Subject: USNRC Docket No. 72-1014, TAC L23657
HI-STORM 100 Certificate of Compliance 1014
HI-STORM License Amendment Request 1014-2, Revision 2, Supplement 3
Clarification of LAR Information

INSTRUCTIONS FOR LAR 1014-2, REVISION 2, SUPPLEMENT 3

FIGURE 4.4.7; RESISTANCE NETWORK MODEL OF A "BOX WALL-NEUTRON ABSORBER-SHEATHING" SANDWICH

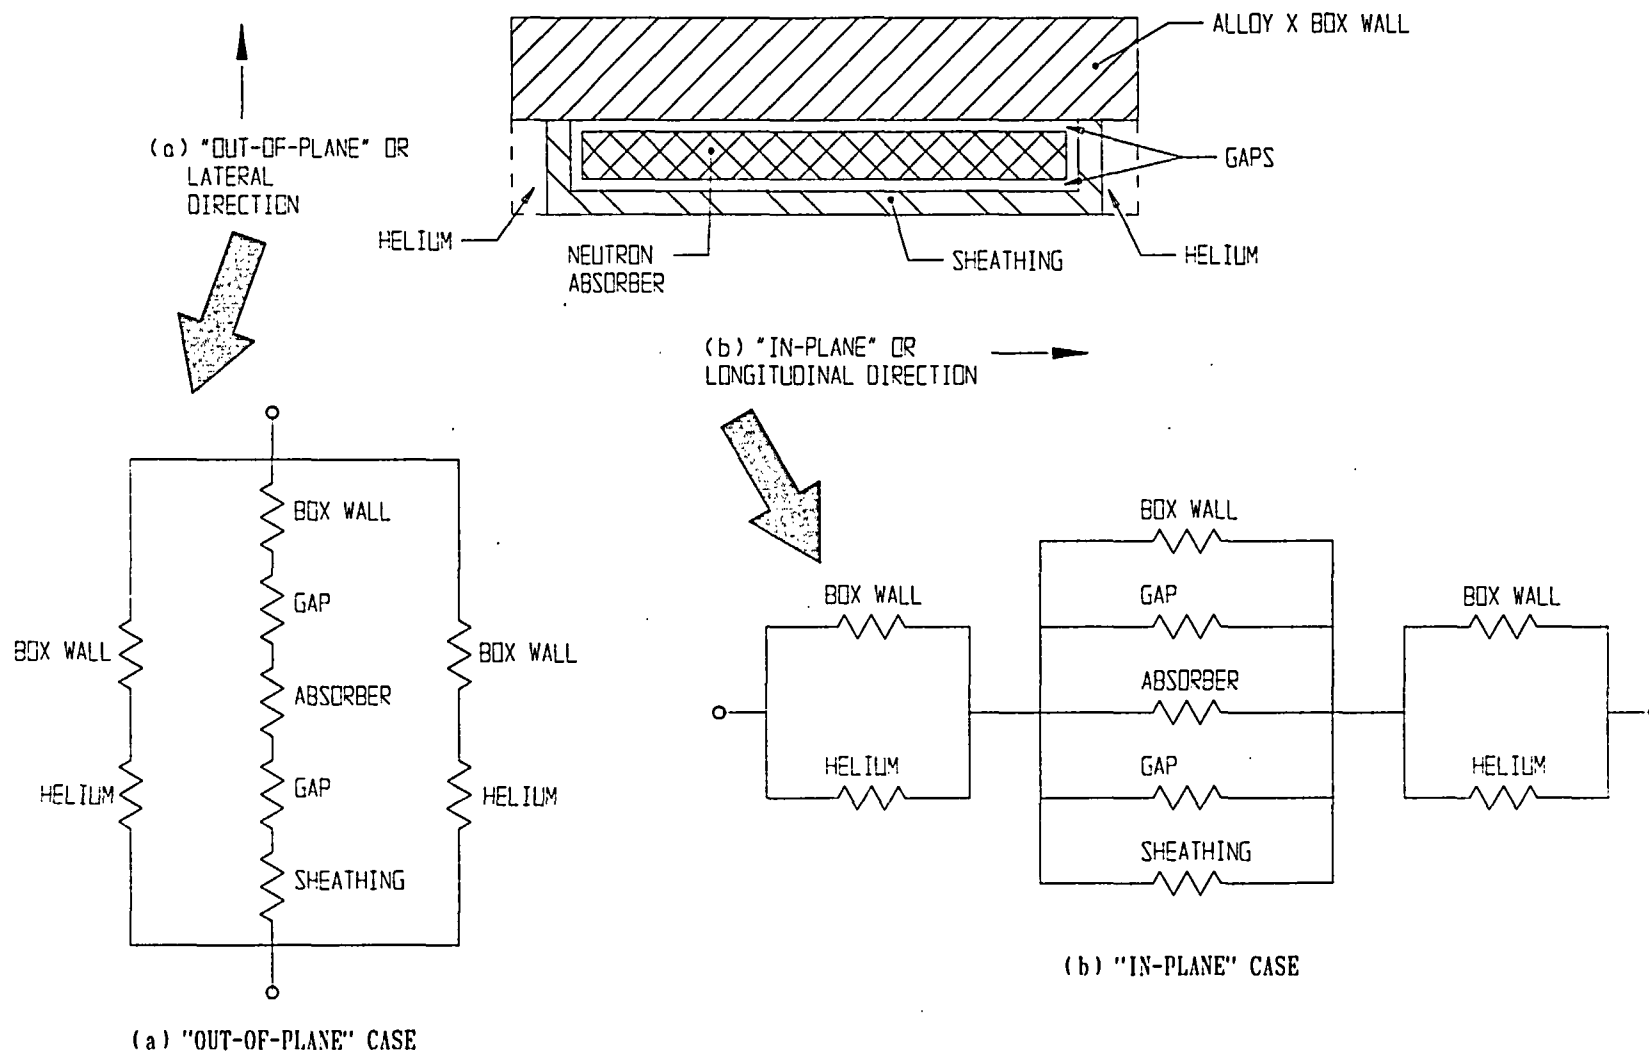
7. Remove FSAR page 4.4-45/46, Proposed Rev. 2C and replace with enclosed FSAR page 4.4-45/46, Proposed Rev. 2D.
8. Replace FSAR Figure 4.4.7, Proposed Rev 2B and replace with enclosed FSAR Figure 4.4.7, Proposed Rev. 2D.
